# LiDAR Quality Assessment Report

UT\_GSLNorth\_2011

This data set was collected from airborne surveys completed between September 27, 2011 and October 10, 2011 and covers approximately 619 square miles contained in the following county(s): Box Elder County, Utah; Weber County, Utah.

Mosaic of original DEM tiles above, many water areas gridded as "no data".

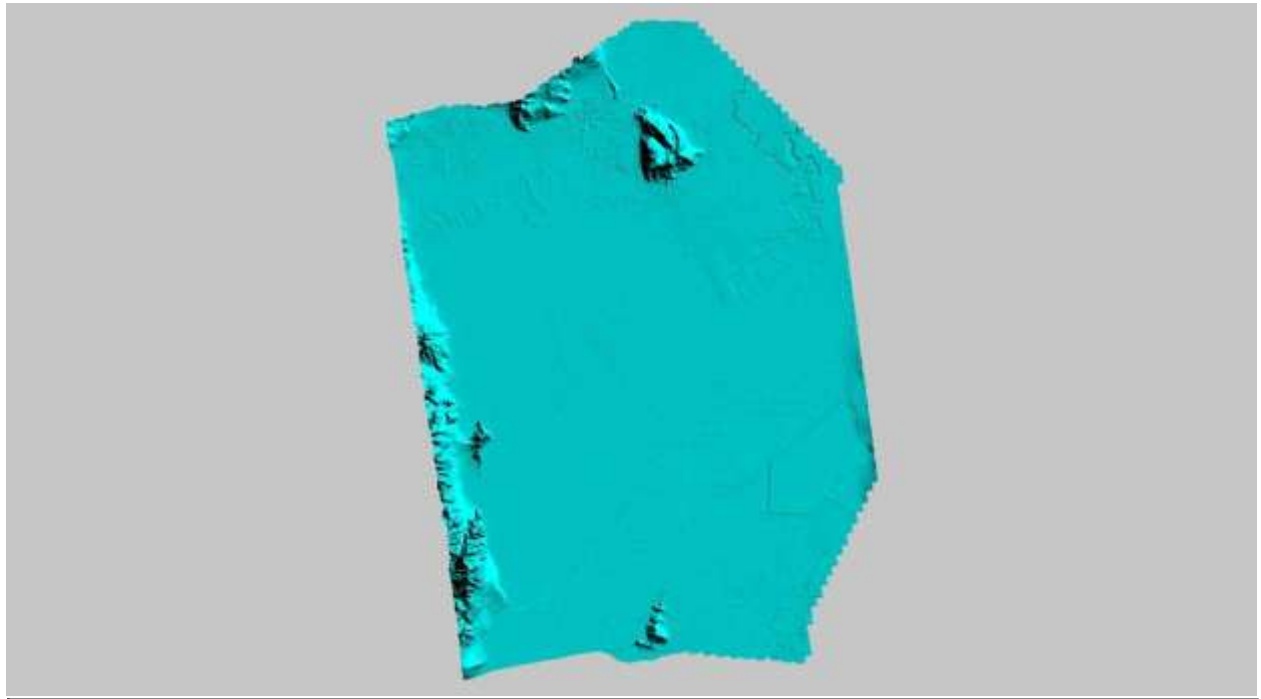
Note that Lake Areas are not gridded at a constant value in DEMs, but is removed or no data.
